PACKARD-CLIPPER DIVISION

# Counselor

VOL. 30, NO. 7

JULY, 1956

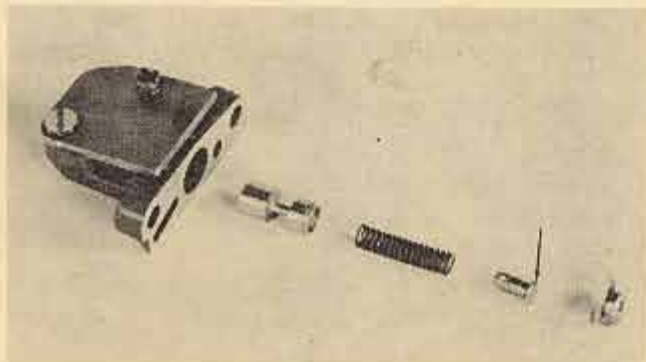
A few reports have been received of the valve keys pulling through the intake valve spring seats on 56th Series cars. This has only occurred on cars that are driven most of the time at extreme high speeds.

Production has corrected this condition beginning with engine numbers A-14403, AA-1597, B-7056, C-1532, D-7719 by using Carbo-Nitrate hardened spring seats on the intake valves.

The new Carbo-Nitrate hardened intake valve spring seats are available and can be ordered under Part No. 6492077. Part No. 440511 seats will continue to be used on the exhaust valves.

When it is known that an owner drives most of the time at extreme high speeds, we suggest replacing the intake valve spring seats with the new hardened seats.

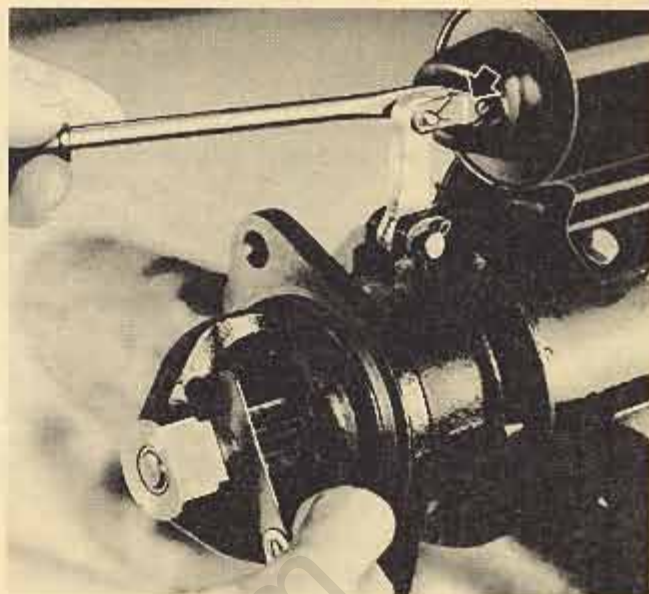
To check Auto-Lite Starter Motor pinion clearance, use a screw driver and press the solenoid plunger inward—NOT THE FORK LEVER—until the plunger bottoms "See illustration". Measure the clearance

between the end of the pinion and the stop on the armature shaft.

The clearance should be  $\frac{3}{32}$  inch, plus  $\frac{1}{32}$  inch or minus  $\frac{1}{64}$  inch. Adjust for proper clearance by screwing the link in or out as required "See arrow".
